# INITIAL FIRE SAFETY INSPECTION REPORT

**AMIGO BANGLADESH LTD**

**RSC ID: 24224**

**Date: 27 September & 03 October 2021**

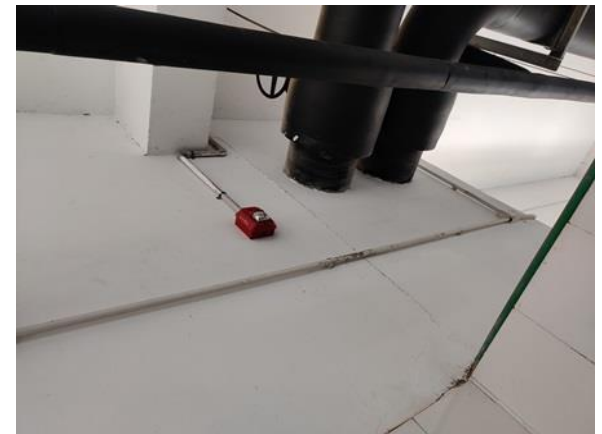
17	Fire Alarm & Detection System (FADS)	<p>Fire alarm and detection system installation requires detailed review to confirm compliance with NFPA 72 and ACCORD standards.</p> <p>Location: All buildings where installed. Also FADS is not provided at washing plant, ETP, WTP and FADS was switched off at daycare building</p>	<p>Submit as-built drawings, testing records, equipment certification and other relevant documentation to the RSC for review.</p> <p>Once reviewed, install or modify the fire detection and alarm system throughout the factory in accordance with Accord standard and NFPA 72. The factory management shall contact RSC to conduct the final acceptance testing after the installation, testing &amp; commissioning.</p>	<p>Design review within 2 months and Installation within 4 months.</p>
----	--------------------------------------	--	--	--

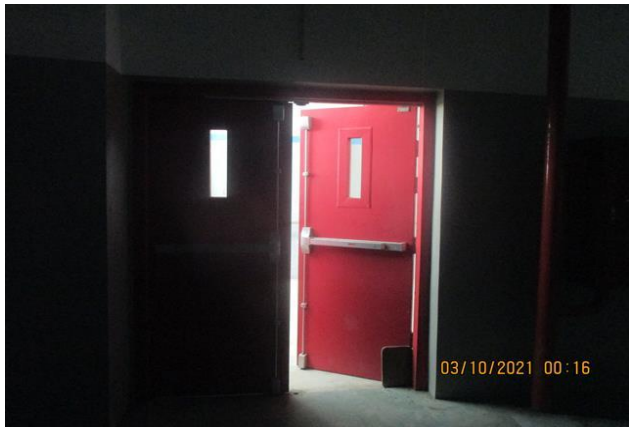
21	Fire Rated Construction	<p>Unsealed penetrations and openings are located in the fire-rated floor/ceiling assemblies.</p> <p>Location: Block-2 &amp; Office Building.</p>	<p>Seal all penetrations and openings in floor/ceiling assemblies to maintain the fire separation at least by 3-hr. The used sealer shall be 3rd party certified and installation shall be as per manufacturer's datasheet.</p> <p>or,</p> <p>Provide a minimum 2-hr fire rated shaft to separate the utility risers from each floor if required.</p>	Within 3 Months
